# Technical Service Bulletin

## 00 - Engine shuts off and/or EPB activates when driver door is opened

46 12 27 2031850/1 November 20, 2012.

Model(s)	Year	VIN Range	Vehicle-Specific Equipment
A6/A7	2013	All	Not Applicable
A8	2013	All	Start-Stop
Q5	2013

Figure 1. Old Start-Stop glovebox insert.

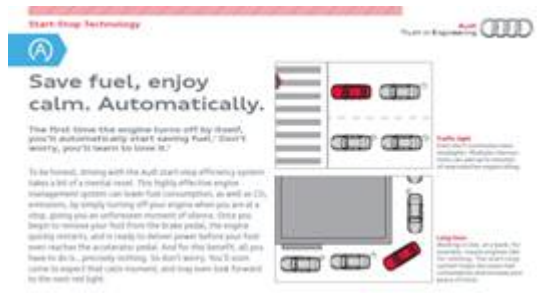
4. If available, replace the old Start-Stop glovebox insert (Figure 1), with the new glovebox insert BR-12-631-US (Figure 2). Additional inserts may be ordered from the Brand Store.
